Site plan review for building demolition (former Yahara School) and new maintenance building at 900 W. Wilson Street. (Postponed from November 13, 2023)
The applicant is requesting site plan approval as described above. This project is one of several the Stoughton Area School District is planning. At the November 13, 2023 Plan Commission meeting, the applicant was directed to come back with a plan to address building aesthetics to enable the building to fit better within the residential neighborhood. We believe the applicant has done a good job addressing the concerns. The application, plans, resolution, staff review and related documents are provided. Plan Commission approval is necessary.

Approving a site plan for Stoughton Area School District at 900 W. Wilson Street, Stoughton, WI.

PLAN COMMISSION REVIEW APPLICATION – PROJECT NARRATIVE

Stoughton Area School District:
Yahara Gym Renovation and Maintenance Building New Build
900 W Wilson St
Stoughton, WI 53589

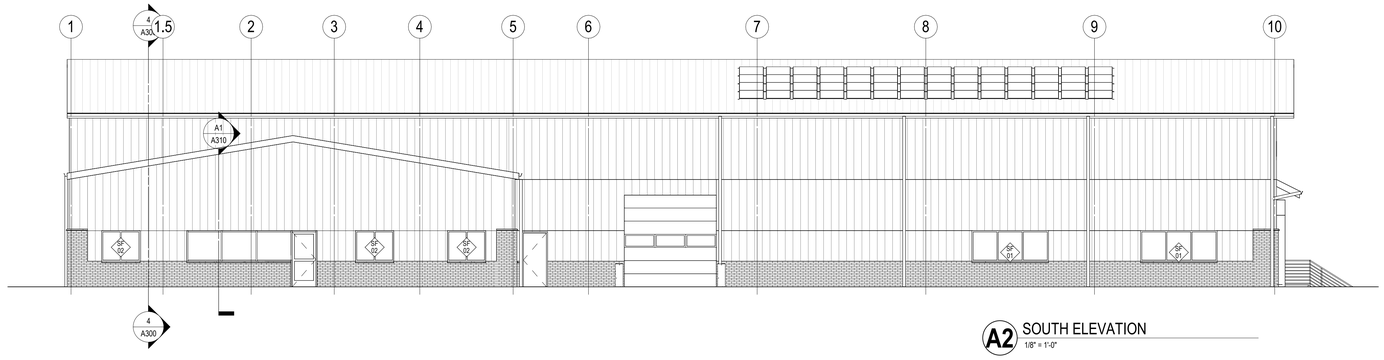
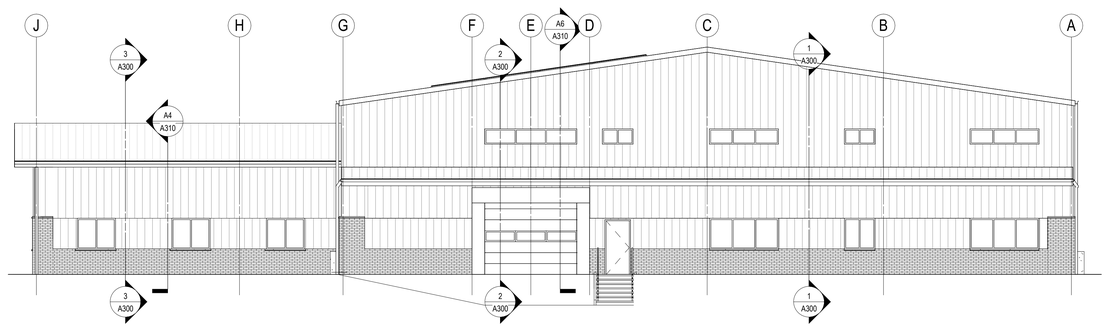
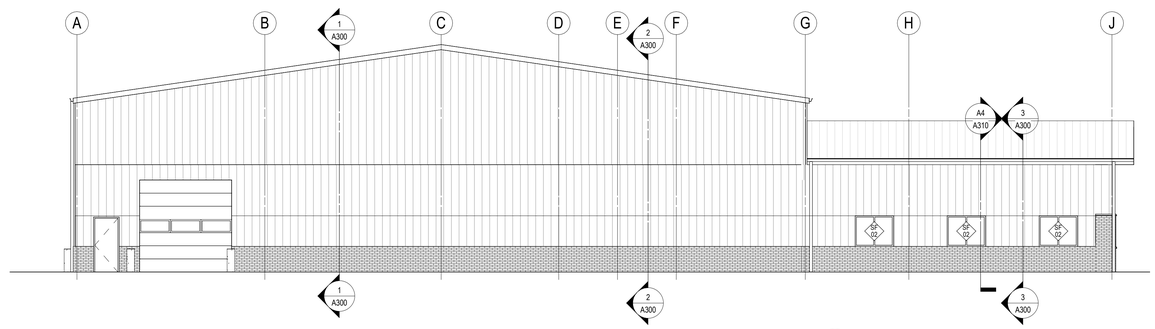
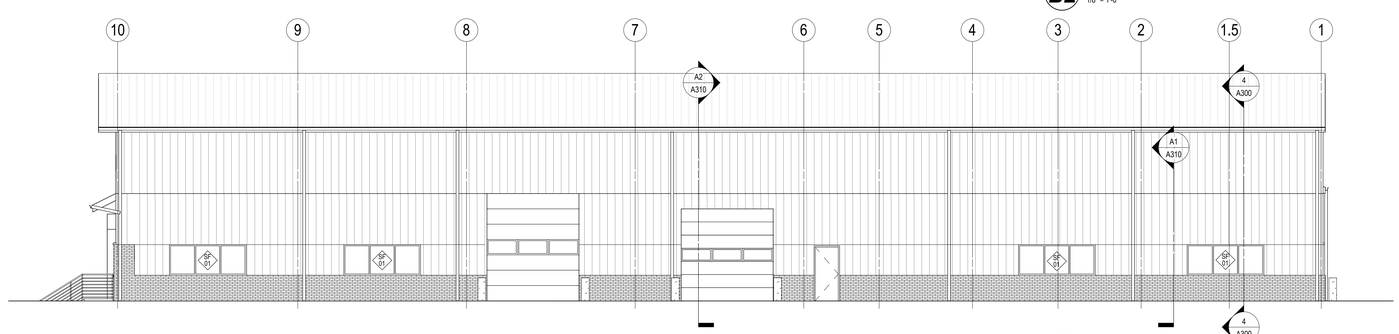
Farrow suggested he sees a net zero change in value since the school building is old, but would like to see the building blend better.

28. Architectural and design elements shall be compatible with the surrounding area and community standards and shall minimize user specific elements as determined by the plan commission. Metal panels with exposed exterior fasteners of the same color may be used on a maximum of 50 percent of the front side of the building. This material is not allowed within 50 feet of any customer or visitor entrance. **As determined by the Plan Commission**.

LANDSCAPE PLAN

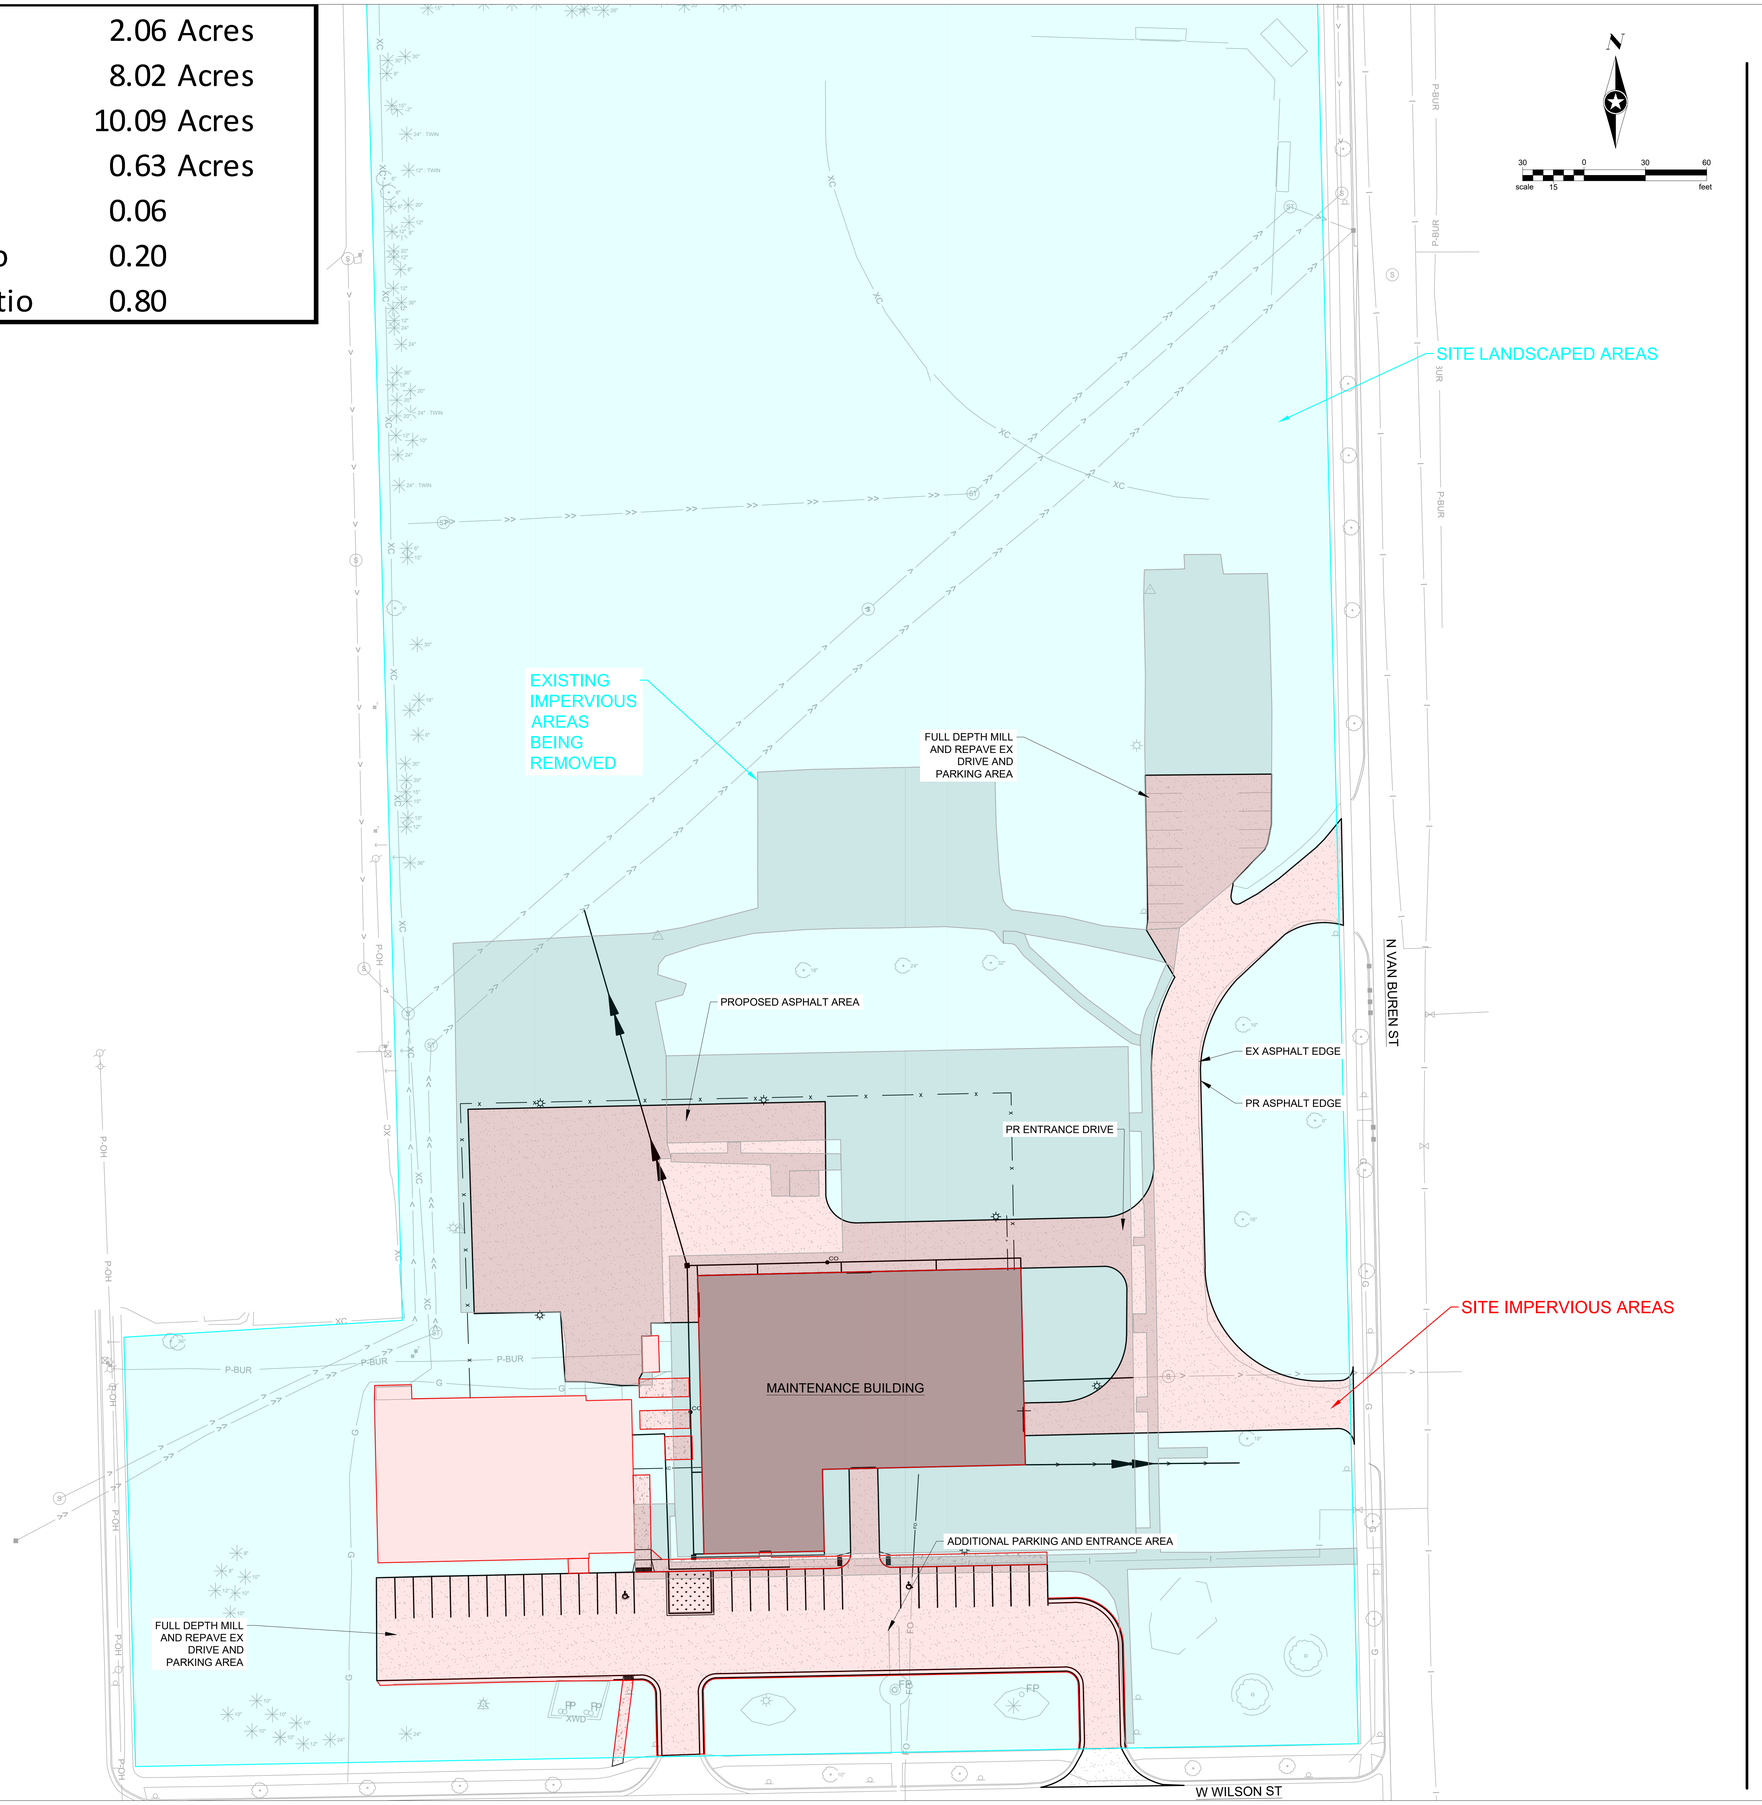
Developed Lot Requirements: Landscaping required by this section is most effective if located away from those areas required for landscaping such as building foundations, street frontages, paved areas, protected green space areas, reforestation areas, and bufferyards. The intent of this section is to provide yard shade and to require a visual screen of a minimum of six feet in height for all detached exterior appurtenances (such as HVAC, utility boxes, standpipes, stormwater discharge pipes and other pipes.)
The site is expected to meet these requirements including the existing plantings. Vision triangle requirements (10 feet) at access drives and street intersections will need to be adhered to at W. Wilson Street and N. Van Buren Street. There appears to be plantings within these triangles.

SITE LIGHTING PHOTOMETRICS PLAN

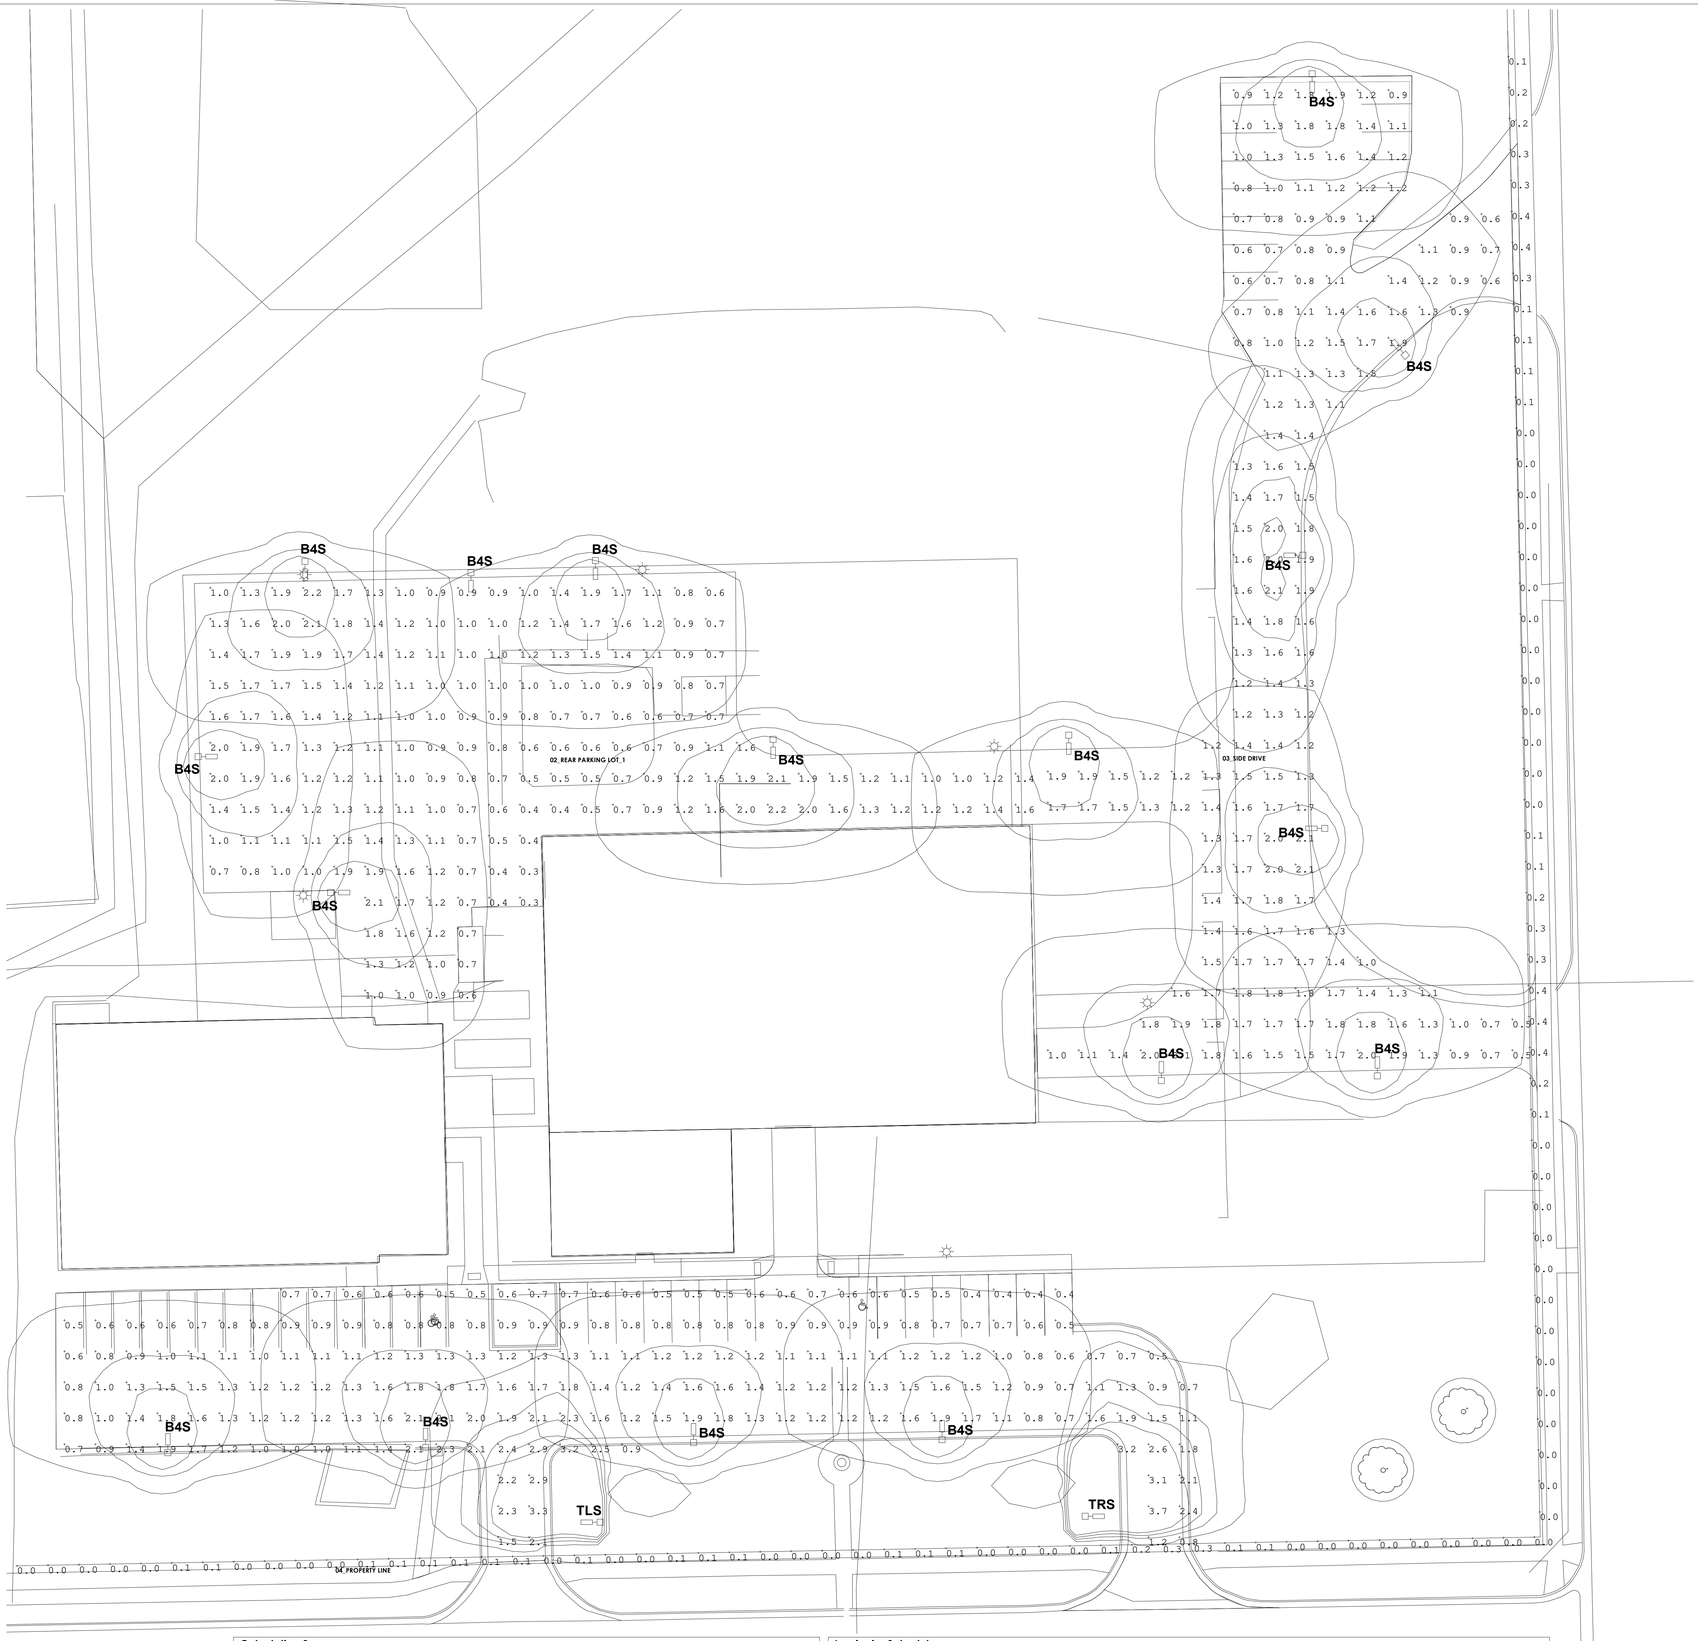
E. A grading and erosion control plan showing existing and proposed grades. **Provided**
   F. Elevation drawings of buildings. **Provided**
   G. A detailed photometric plan with an illumination limit of 0.5 foot-candles at the property line. The plan must meet the requirements of section 78-707. **Provided.**
